Addendum No. 1

Reference: Elevator Modernization-Provo Regional Center
Division of Facilities Construction and Management
DFCM Project No. 15038310

Subject: **Addendum No. 1**

PENTHOUSE FIRE ALARM PLAN
1/8" = 1'-0"

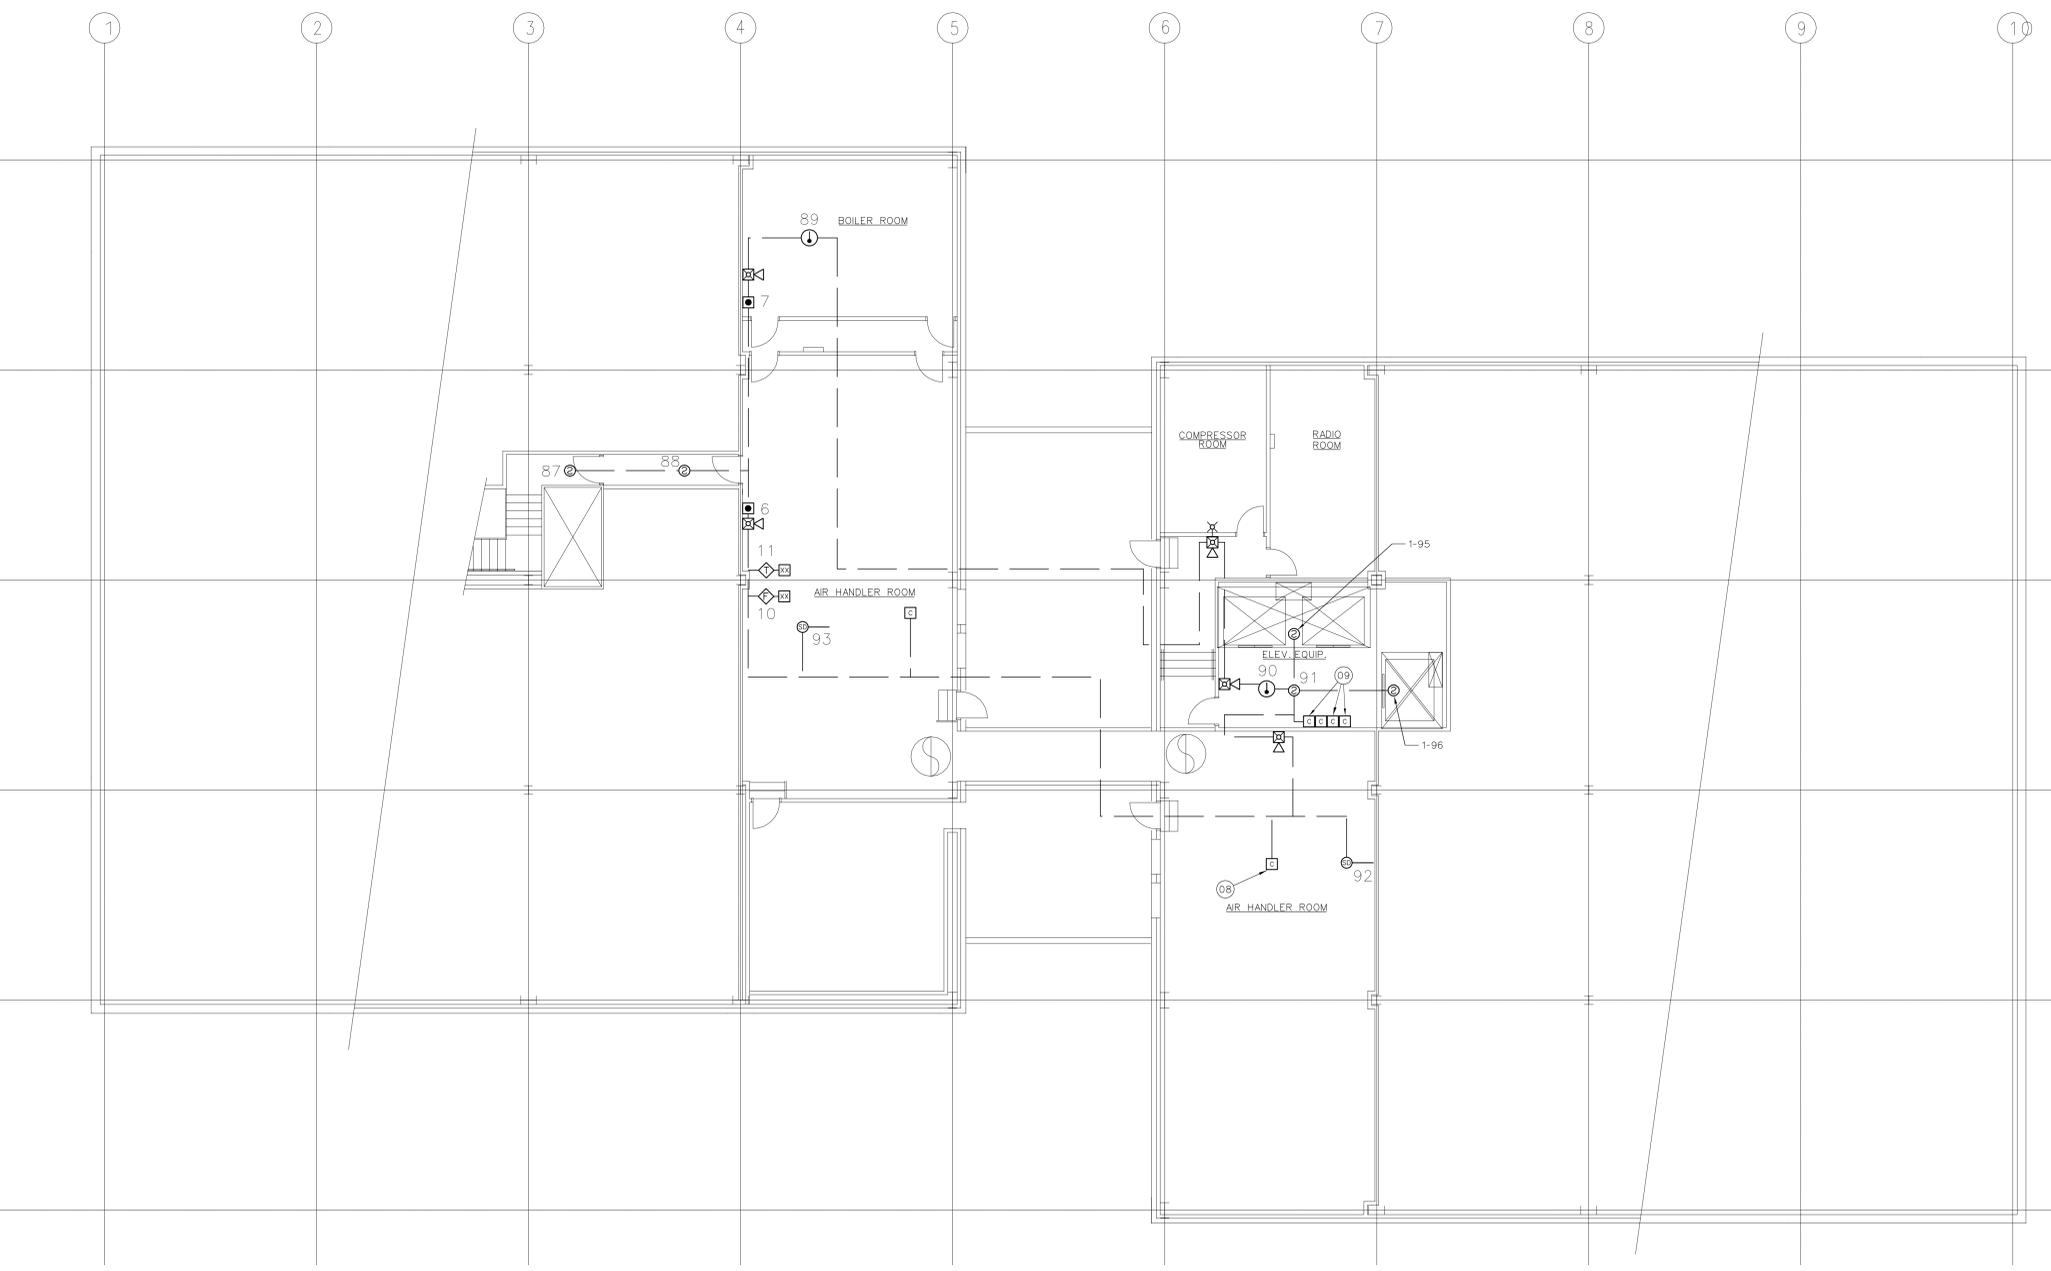
8. Is a building layout drawing available for bidders to review and plan accordingly?

Yes, attached to the addendum are the building's Fire Alarm System drawings per floor and also you can visit the building's haz-mat survey pages 57 through 63 entitled Floor Plans.
